**PURCHASING SECTION**  
 13450 – 104 Avenue, Surrey BC V3T 1V8  
 Tel: 604-590-7274  
 E-mail: [purchasing@surrey.ca](mailto:purchasing@surrey.ca)  
**ADDENDUM #1**

**REQUEST FOR QUOTATIONS (RFQ) NO.:** 1220-040-2019-006  
**TITLE:** PARTIAL RE-ROOFING AND ROOF MAINTENANCE AT R.C.M.P. HEADQUARTERS BUILDING  
**ADDENDUM ISSUE DATE:** January 18, 2019  
**CLOSING DATE:** prefer to receive Quotations on or before:  
 January 30, 2019

**REVISED ROOF PLAN**

Project: Surrey RCMP Headquarters

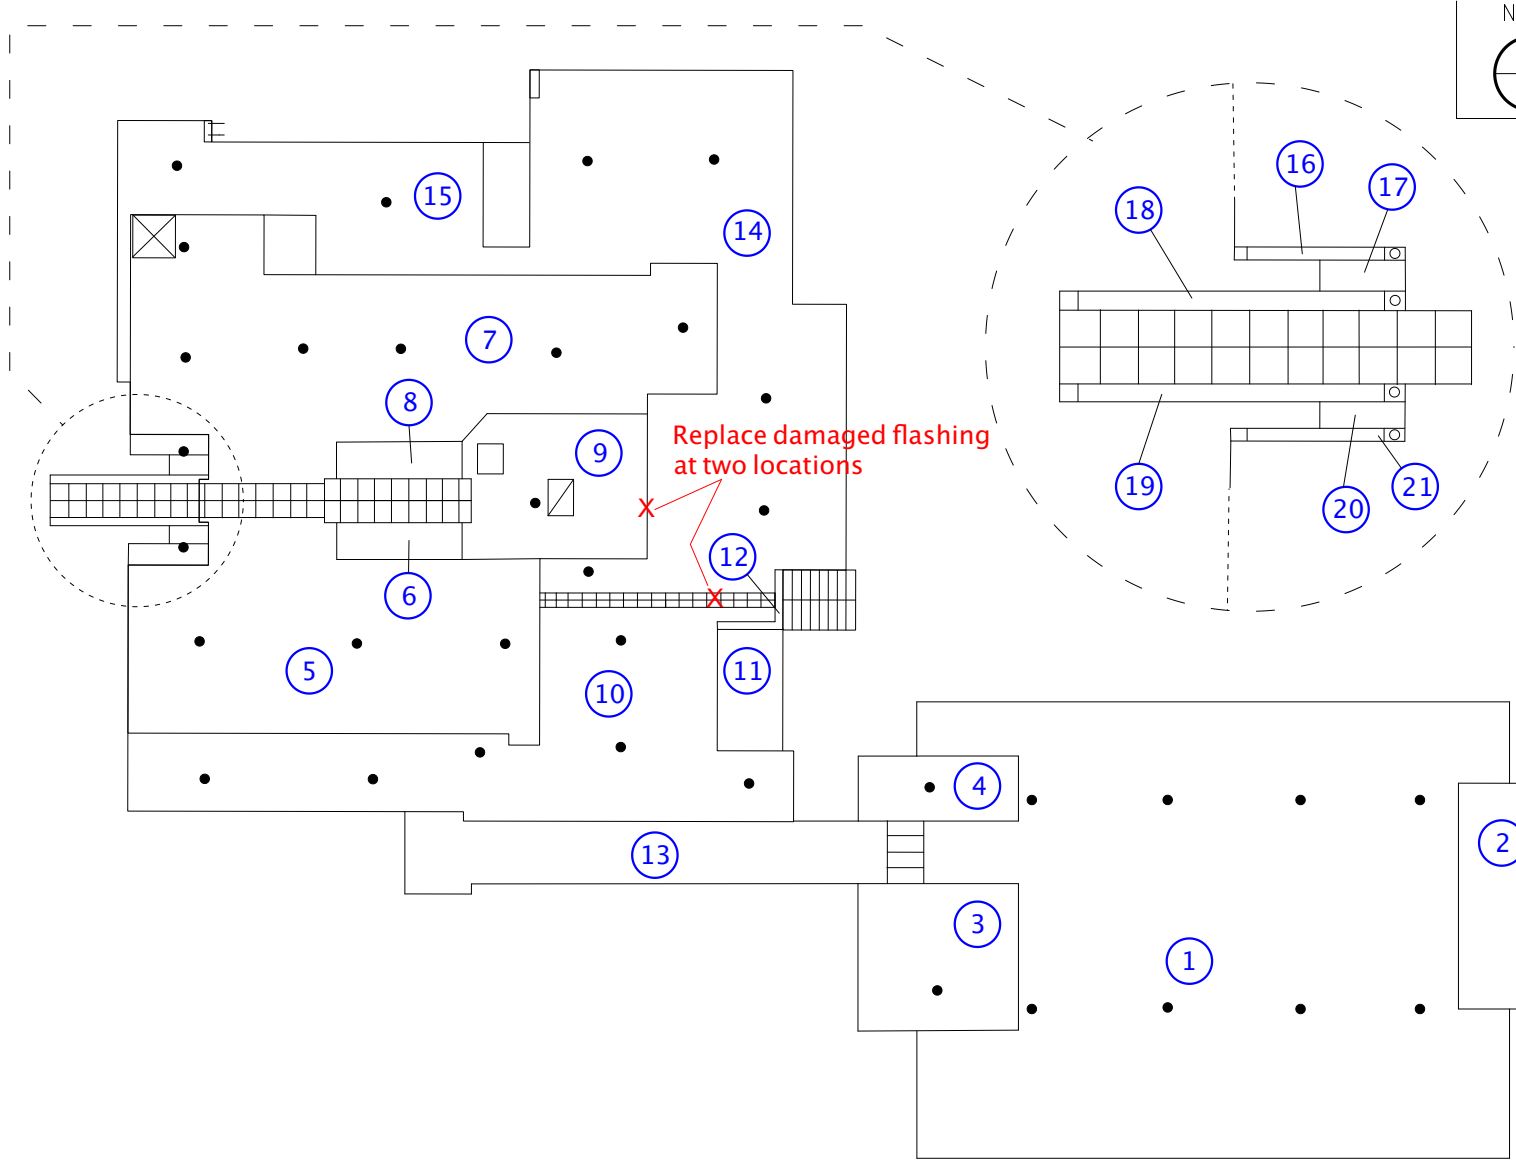
- 3) Contractors are to remove and replace the damaged flashing on the skylight of roof area 10 and the cap flashing on the north end of roof area 9. Refer to the attached Revised Roof Plan for approximate location of repairs. Contractors are to include the cost of these repairs in their Total Quotation Price.

Replace damaged flashing  
at two locations
